**SITE PLAN REVIEW TECHNICAL ADVISORY COMMITTEE
PORTSMOUTH, NEW HAMPSHIRE**

June 4, 2024

AGENDA

TITLE
**EXISTING
CONDITIONS
PLAN**
806 US-1 BYP.
PORTSMOUTH, NH 03801
TAX MAP 161, LOT 43

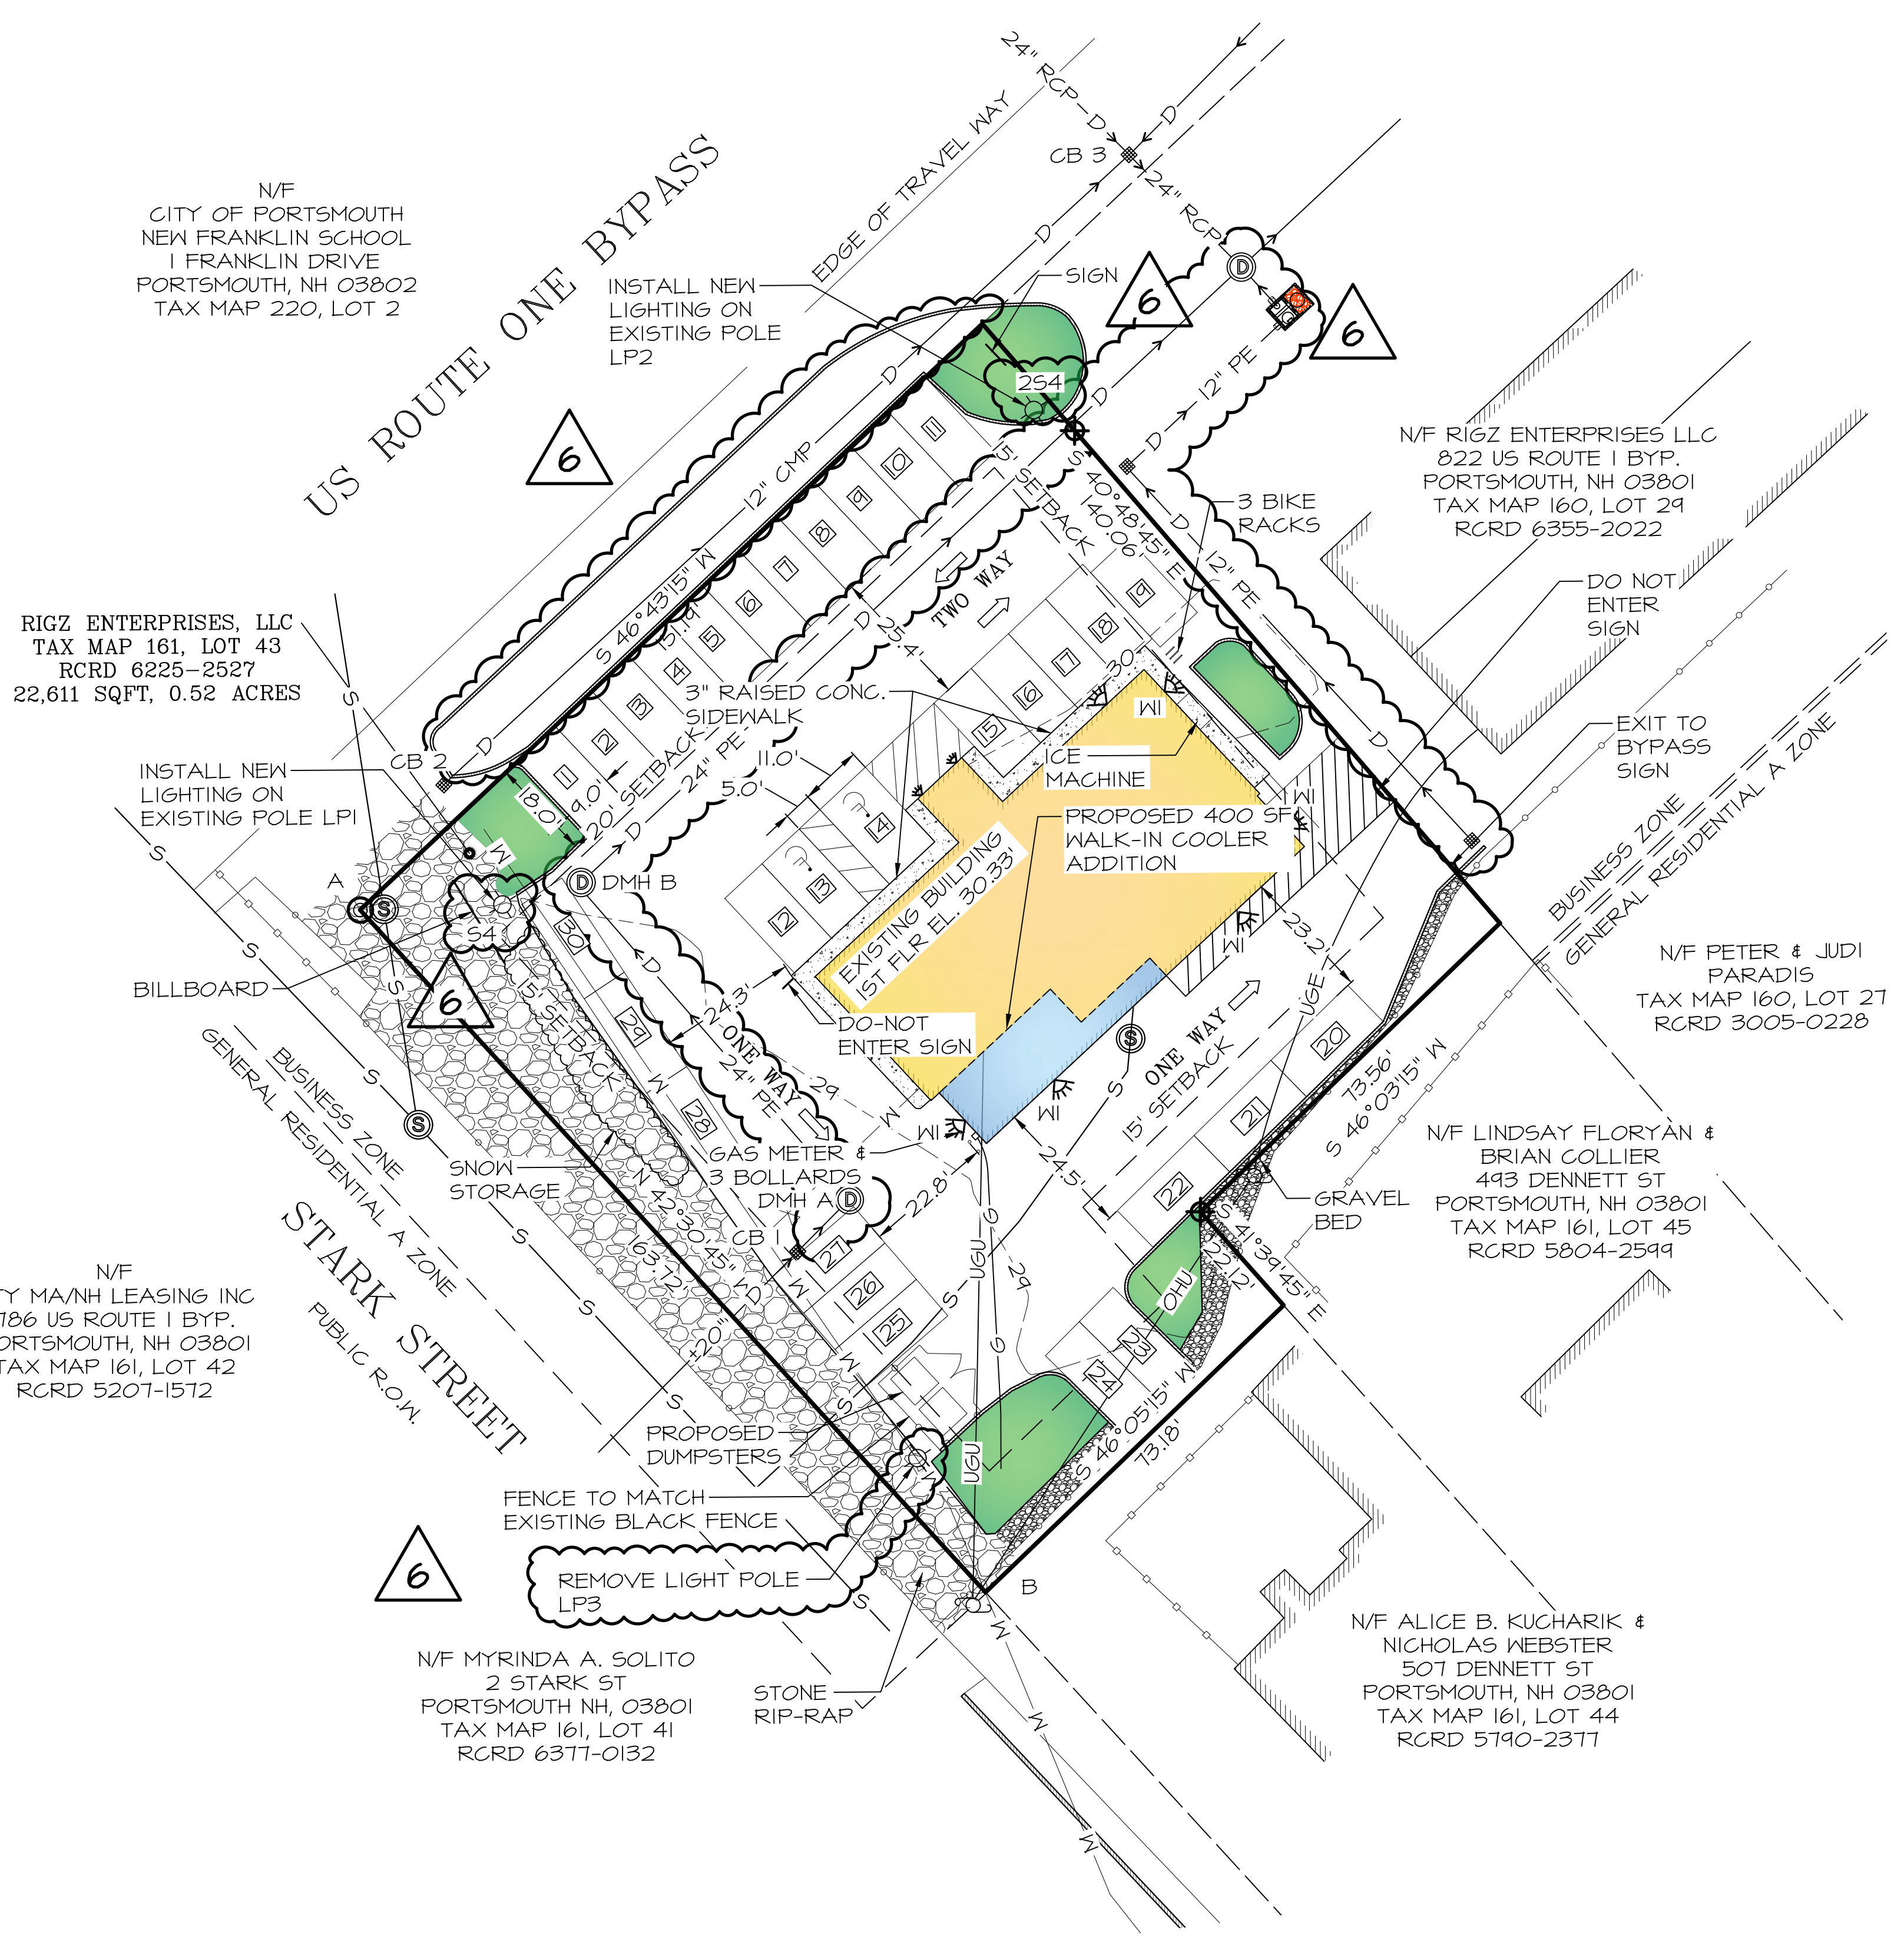
Drawing 1 – Existing Conditions Plan

- Revised existing catch basin elevations
- Added note 6 outlining PB approval and extension of approval.

- REVISED CATCH BASIN ELEVATIONS
- ADDED NOTE 6 TO OUTLINE PB APPROVAL AND EXTENSION OF THIS PROJECT.
